Evaluation of proposed move for Water Right Nos. 7245 & 7433

Proposed: Move water right no. 7245 to the well location currently authorized under water right no. 7433. Move water right no. 7433 to the well location currently authorized under water right no. 7245. These wells do not meet spacing rules to each other and a waiver to spacing rules will be needed to process the application.

Data Set: C:\Users\trevora\Documents\2023_moves\7245_7433\7245 & 7433 Current.aqt

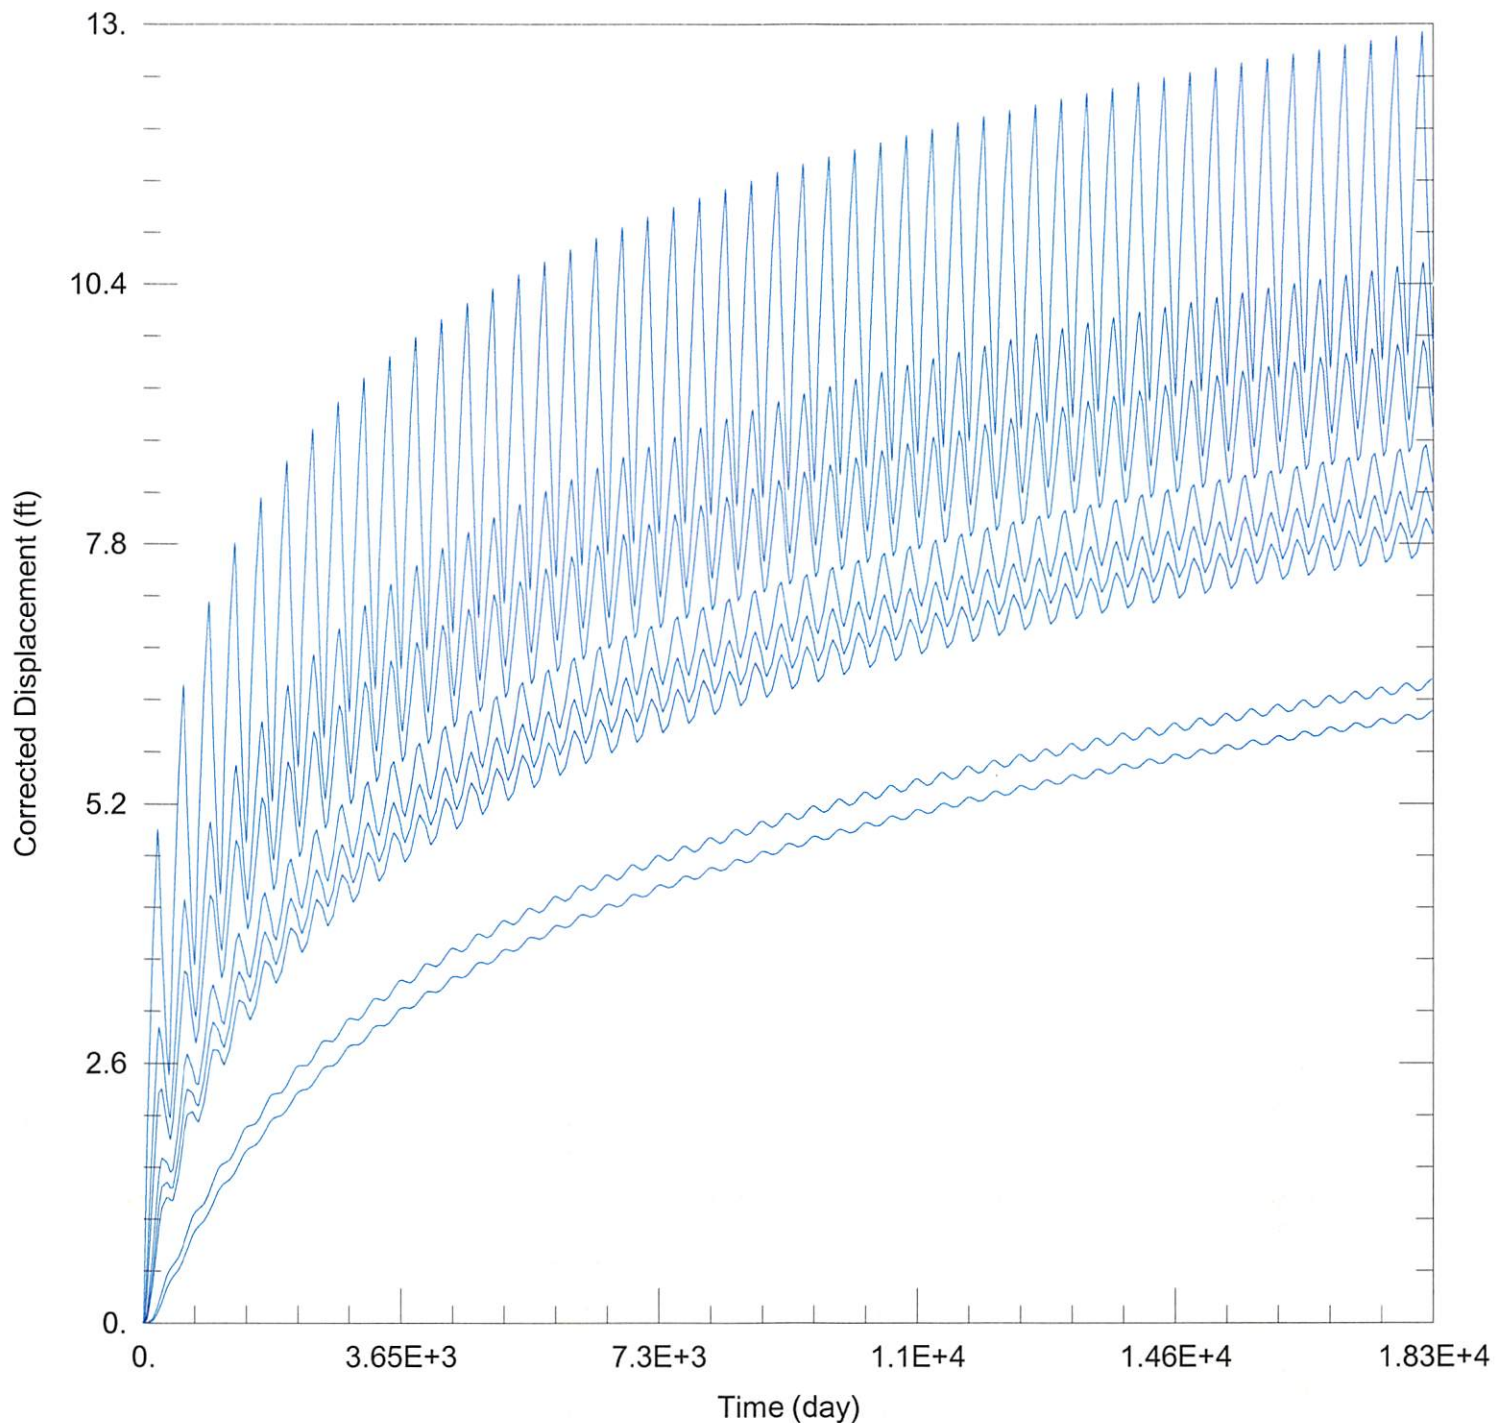
50 year Theis Analysis: The following values were used to run the analysis:

$S = 0.1935$, $T = 2324 \text{ ft}^2/\text{day}$, $t_{p\text{current}} = 206 \text{ days}$, $Q_{\text{current}} = 539 \text{ gpm}$, $t_{p\text{proposed}} = 282 \text{ days}$, $Q_{\text{proposed}} = 539 \text{ gpm}$

19614: Drawdown from current location = 6.43 ft
Drawdown from proposed location = 8.77 ft
Net drawdown = 2.3 ft

19052:	Drawdown from current location = 8.37 ft Drawdown from proposed location = 11.29 ft Net drawdown = 2.9 ft
8766:	Drawdown from current location = 8.05 ft Drawdown from proposed location = 10.90 ft Net drawdown = 2.8 ft
7433:	Drawdown from current location = 9.83 ft Drawdown from proposed location = 13.09 ft Net drawdown = 3.3 ft
6809:	Drawdown from current location = 6.12 ft Drawdown from proposed location = 8.34 ft Net drawdown = 2.2 ft
Domestic 12-27-38:	Drawdown from current location = 12.92 ft Drawdown from proposed location = 16.54 ft Net drawdown = 3.6 ft
Domestic 13-27-38:	Drawdown from current location = 10.61 ft Drawdown from proposed location = 13.99 ft Net drawdown = 3.4 ft

Net drawdown exceeds the drawdown allowance for all wells within 1 mile of the proposed location.
Critical well analysis is necessary on those wells.
